Planning Commission Meeting Agenda
Hartland Township Hall
Thursday, April 25, 2024
7:00 PM

Hartland Township Planning Commission Meeting Agenda Memorandum

Subject: Site Plan PD Application #24-003 Redwood Living Planned Development (PD) Phase II – Preliminary PD Site Plan

Sheet #
L1.0

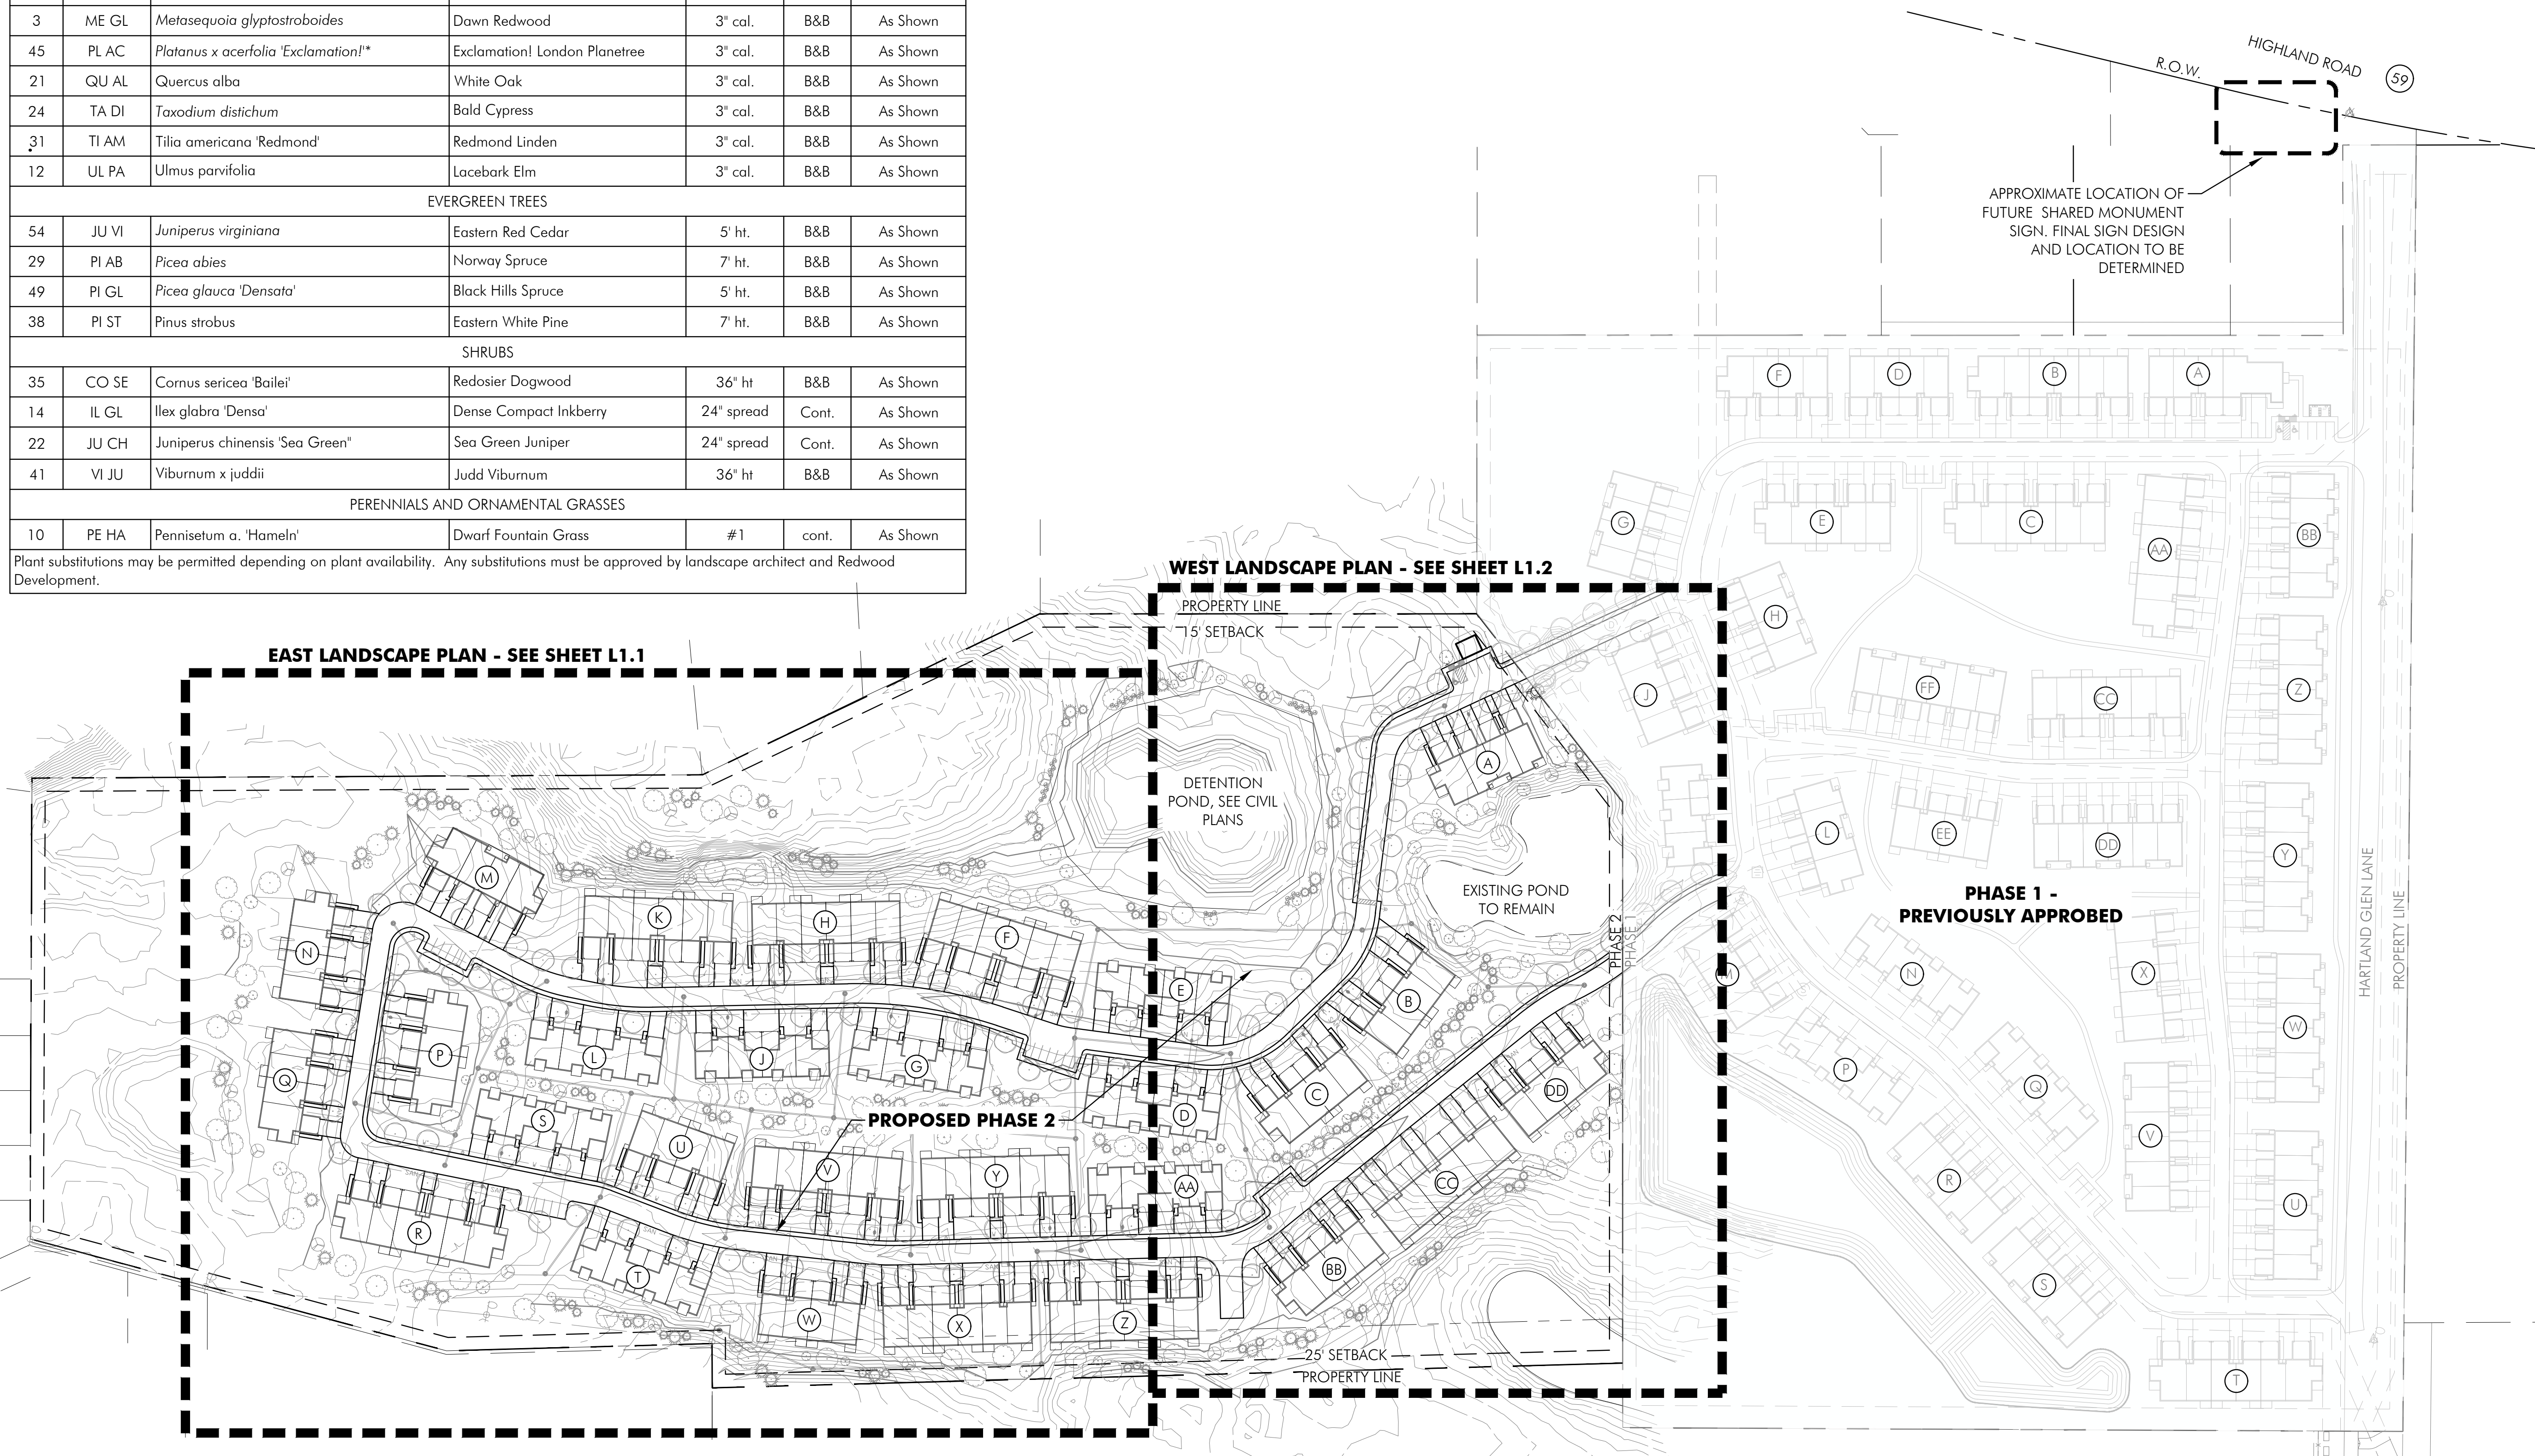
Sheet L1.0 has a Plant Schedule for all plant materials. The required height for an evergreen tree at the time of planting is eight (8) feet and several evergreen trees are less than eight (8) feet in the chart. The plant schedule shall be revised on the Construction Plan set for the height of all evergreen trees (Norway Spruce, Black Hills Spruce, and Eastern White Pine).
